DESIGN SPECIFICATION

ACCESSIBILITY

Harbord Beach Hotel

It relates to the proposed **Works Package** associated with a s4.55 application for the undertaking of alterations and additions to the existing building known as the Harbord Beach Hotel, as is located at 29 Moore Road, Freshwater.

Figure 2.1.1 – proposed s4.55 ground floor plan

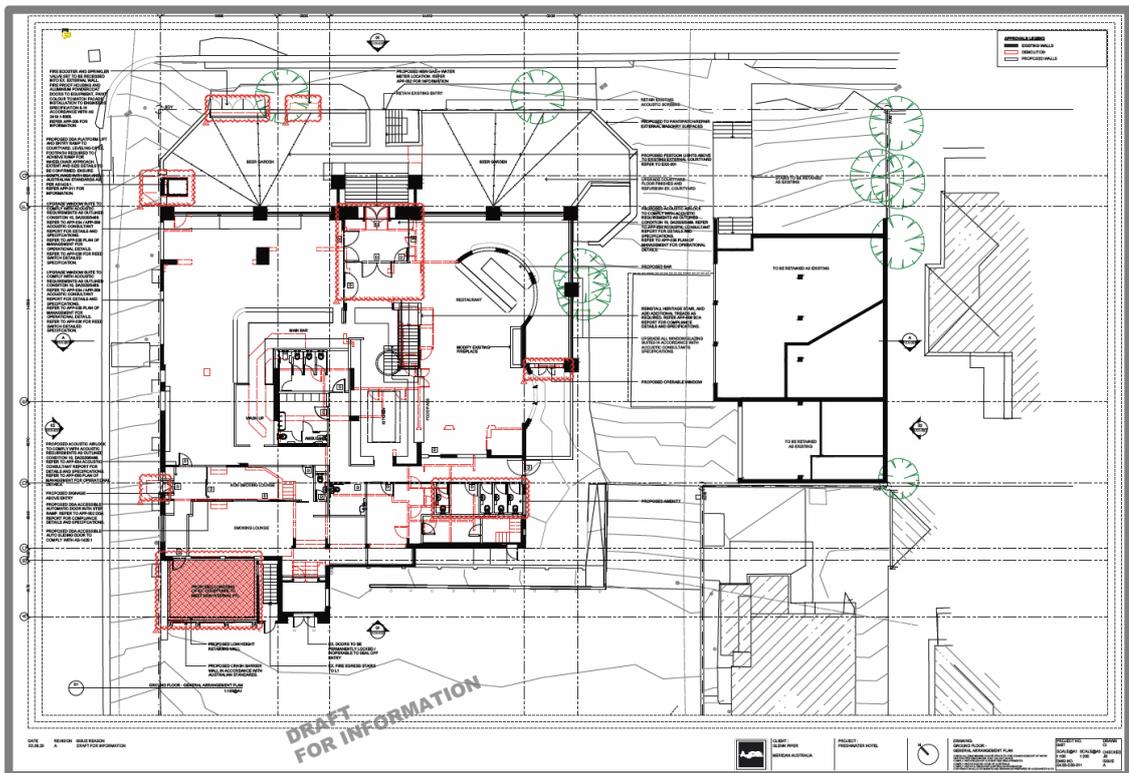
1. New DDA entry from Charles Street, on the footpath side of the doorway opening . refer Clause D3.2 above, as an automatic opening device to this door leaf is required;
2. Sliding door from the restaurant to the corridor / opposite the proposed lift . the wall nib on the latch side of the sliding door leaf need be not less than 530-mm to both sides of the opening (see also figure D3.2.1 above).
3. Sliding door from the hallway to the gaming machine lounge adjacent gaming machine 1 . unless the door leaf is automated, a minimum 530-mm circulation space is required to the latch side of the door leaf, on both sides of the opening (see also figure D3.2.1 above)
4. The swing door from the corridor adjacent to the ground floor smoking lounge to the external courtyard . a 530-mm circulation space is required to the latch side of this door leaf, on the corridor side of the doorway opening.

Figure D2.17.1 – AS 1428.1-2009 handrail extensions to stairways

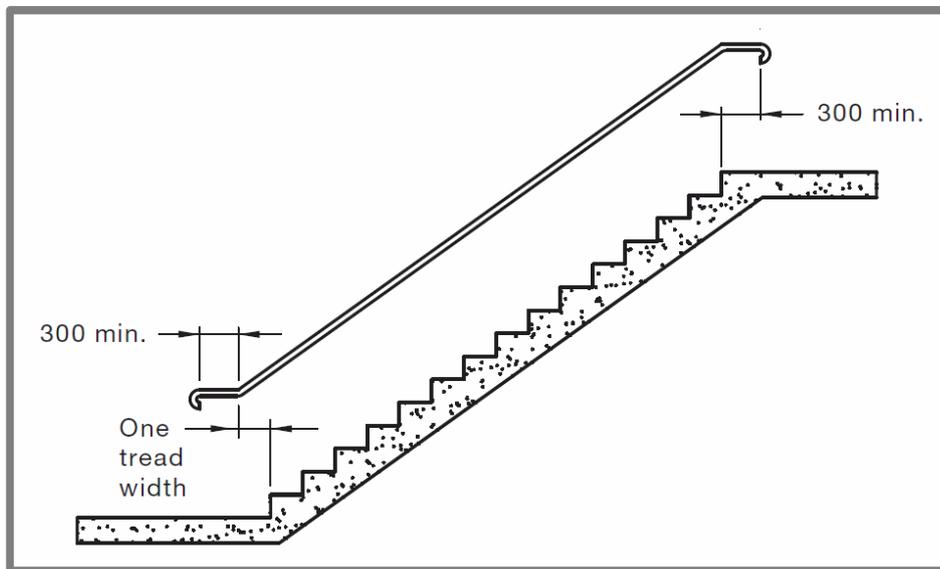
This includes the re-built stairway connecting the ground and first floors; the re-built stairway leading to the main entry into the ground floor from Moore Road; and the stairway descending to the Moore Road footpath.

It is noted though, that there will be difficulty providing the AS 1428.1-2009 handrail extensions to the latter two (2) stairways, as such will cause obstruction to the accessways associated thereto (refer AS 1428.1-2009 excerpt in figure D2.17.1 below).

As such, for these two (2) particular stairways, it is instead proposed that a performance solution be employed whereby the handrails are terminated at the ends of the stairway (without extension) and AS 1428.2-1992 compliant dome buttons installed to the rails.

Figure D3.2.1 – new accessible entry into building

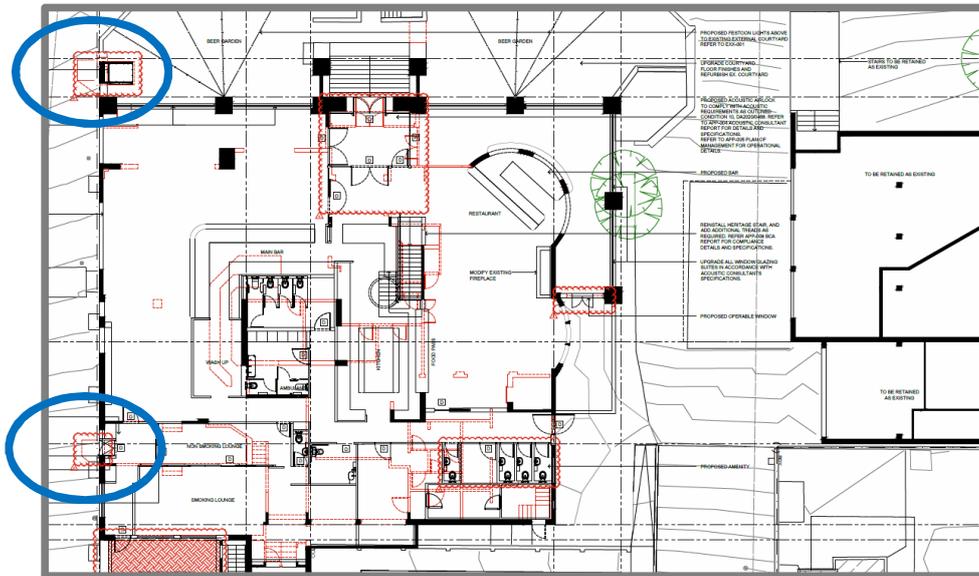
It is acknowledged though that the existing and heritage construction at the main entry to the site from Moore Road prevents the provision of access for mobility impaired persons at that location.

- (a) A new accessible entry point into the ground floor be provided along the Charles Street elevation of the building (see figure D3.2.1 below);
- (b) The new accessible entry mentioned in (a) above shall incorporate .
 1. A threshold ramp to connect the doorway opening and the footpath;
 2. A doorway opening not less than 850-mm;
 3. An automatic opening device to the door leaf, activated by a push button located externally and accessible to an approaching wheelchair user PRIOR to accessing the threshold ramp

- (d) A new accessible entry point into the front Beer Garden along the Charles Street elevation (see figure D3.2.1 below);
- (e) The new accessible entry mentioned in (d) above shall incorporate .

In this respect, it is instead proposed that a performance solution be pursued that contains the following features .

(NB: the door leaf must automatically stay open for a sufficient period to allow a wheelchair user to enter);
 4. An external intercom connected to the bar area or Managers office, so that an attending mobility impaired person can contact staff and alert them if the automatic operation of the door leaf is broken or otherwise malfunctioning;

5. External signage identifying that the subject opening IS an accessible entry into the building.
- (c) Signage shall be installed adjacent to the main entry to the site from Moore Road, in a clearly visible location from the footpath, identifying the availability of the aforementioned accessible entry into the building.

1. A platform lift that connects the Charles Street footpath with the level of the Beer Garden;
 2. Modification of the footpath and area just inside the allotment to create AS 1428.1 compliant transition between cross falls and levels;

3. Internal and external signage to denote the access route provided by this entry point into the Beer Garden.
